# PARTS & SERVICE

REF NO.	AT04024			
DATE	Feb. 5, 2004			
(C)	Page 1 of 8

SUBJECT: IMPROVED DURABILITY PARTS OF FRONT AND REAR SUSPEN-

SIONS ON HD465-5/-7 AND HD605-5/-7

## (1) Front suspension

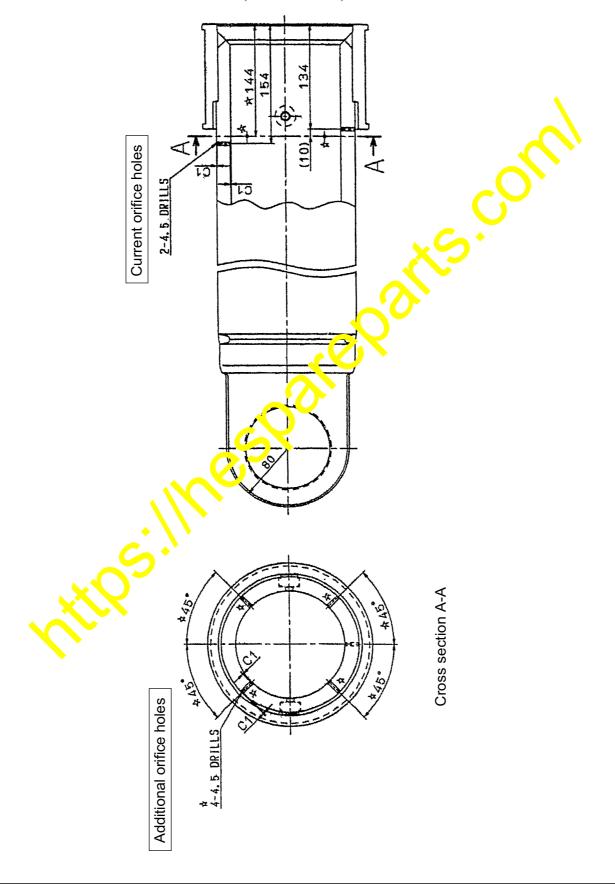
Improved s	uspension	Current suspension		
Contents of the modification	<ul> <li>The material of the changed.(DD ← DI</li> <li>A buffer ring has been as the flange has been as the flang</li></ul>	U) een added.			
Structure	24 873				
	2. Buffer ring	707-51-16640			
Part No.	3. Bushing 569-50-6A180 4. Flange 569-50-65140		<ul><li>3. Bushing</li><li>4. Flange</li></ul>	566-50-11180 569-50-61141	
Par	7. O-ring 8. Backup ring	07000-15190 07001-05190	7. O-ring 8. Backup ring	07000-15190 07001-05190

\* No. 7, 8 parts are consumable parts.
